A	Analysis sheet N/A / attached		Expiry D	ate:	14/01/2025	
N					22/12/2024	
		Application N	lumber(s)			
Sofie Fieldsend		\ <i>\</i>	(i)2024/4841/P (ii) 2024/5069/L			
Application Address		Drawing Num	Drawing Numbers			
47 Mount Pleasant London WC1X 0AE PO 3/4 Area Team C&UD		See decision r	See decision notice			
Area Team C&UD Signature		Authorised Officer Signature				
Proposal(s)						
<ul> <li>i) Change of Use from Commercial (Class E use) to a 6bed House in Multiple Occupation (HMO) (Sui Generis use). Replacement front door.</li> <li>ii) Change of Use from Commercial (Class E use) to a 6bed House in Multiple Occupation (HMO) (Sui Generis use) and associated internal alterations. Replacement front door.</li> </ul>						
(i)Refuse planning permission (ii) Refuse Listed Building Consent						
(i)Full Planning Permission (ii) Listed building consent						
Refer to Decision Notice						
		No. of responses	<b>o</b> ot N	ojections o. of	<b>o</b> 00

# 1.0 Proposal

- 1.1 Planning permission is sought for the following:
  - Change of Use from Commercial (Class E use) to a 6bed House in Multiple Occupation (HMO) (Sui Generis use).
  - Replacement front door.

Figure 1: Photo provided by the applicant looking from the rear ground floor room across the lightwell towards the front the property.

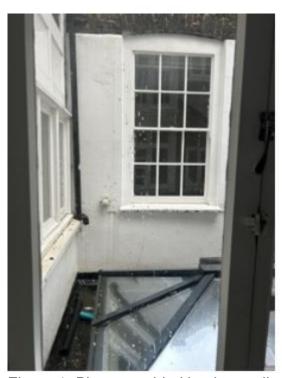
- The development would fail to provide an adequate level of amenity for the occupants of the proposed HMO. This is specifically the case for the two bedrooms rooms facing onto the lightwell at ground floor. The only source of light and outlook for both these rooms would be to this lightwell and the main windows would directly face each other across the lightwell (as shown in figure 1 below). These windows are in very close proximity at only 2.5m apart. It is considered that this arrangement would result in overlooking and loss of privacy to these rooms as well as resulting in a poor quality outlook for the occupants.

- 6.7 No assessment was submitted with the application to demonstrate that the internal light levels of daylight and sunlight within the two bedrooms would meet BRE minimum standards. Given the position and scale of the openings, location at the lower level within a narrow lightwell, it is unlikely that adequate levels of daylight and sunlight would reach these rooms. As previously mentioned access to the site was not permitted by the applicant for officers to assess the light levels in person.
